UNITED STATES  
DEPARTMENT OF THE INTERIOR  
BUREAU OF LAND MANAGEMENTFORM APPROVED  
OMB NO. 1004-0137  
Expires: January 31, 2018**SUNDRY NOTICES AND REPORTS ON WELLS**  
*Do not use this form for proposals to drill or to re-enter an abandoned well. Use form 3160-3 (APD) for such proposals.*5. Lease Serial No.  
NMNM125057

EAST BLINEBRY DRINKARD UNIT 80

Apache is requesting approval to perform a cleanout and work on this well, as follows:

**East Blinebry Drinkard Unit 80**  
**30-025-39674**  
**Apache Corporation**  
**Conditions of Approval**

Blinebry Proposed; 5,722.00-5,864.00

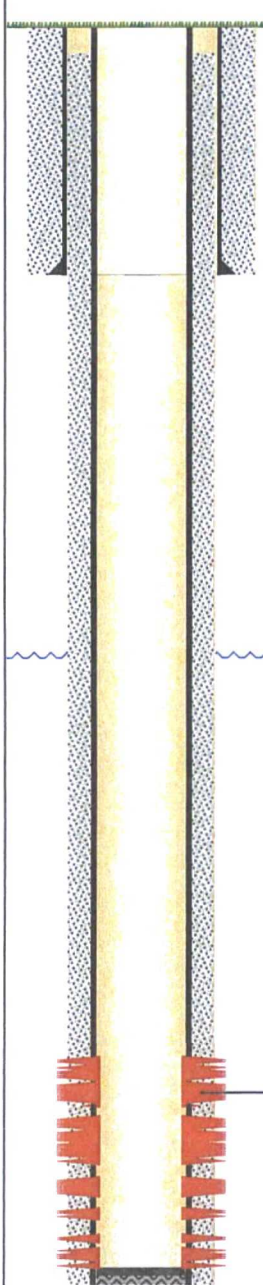
1. POH with production equipment.
2. TIH with bit to clean out to PBTD.
3. Set a RBP above the existing Tubb completion.
4. Perforate new Blinebry pay from 5722 to 5864. Existing Blinebry completion is from 5624 to 6038.
5. Restimulate the entire Blinebry with acid.
6. Pull RBP above the Tubb.
7. Run production equipment and RWTP.

1. Must conduct a casing integrity test before perforating and fracturing. Submit results to BLM. The CIT is to be performed on the production casing to max treating pressure. Notify BLM if test fails.

7. A minimum of a 2000 (2M) BOP to be used. All blowout preventer (BOP) and related equipment (BOPE) shall comply with reasonable well control requirements. A two ram system with a blind ram and a pipe ram designed for the size of the work string shall be adequate. Tapered work strings will require an additional pipe ram. The manifold shall comply with Onshore Oil and Gas Order #2 Attachment I (2M Diagrams of Choke Manifold Equipment). The accumulator system shall have an immediately available power source to close the rams and retain 200 psi above pre-charge. The pre-charge test shall follow requirements in Onshore Order #2.
8. **Subsequent sundry required detailing work done, a C-102 form, and completion report for the new formations. Operator to include well bore schematic of current well condition when work is complete.**
9. **See attached for General Plugback Guidelines**
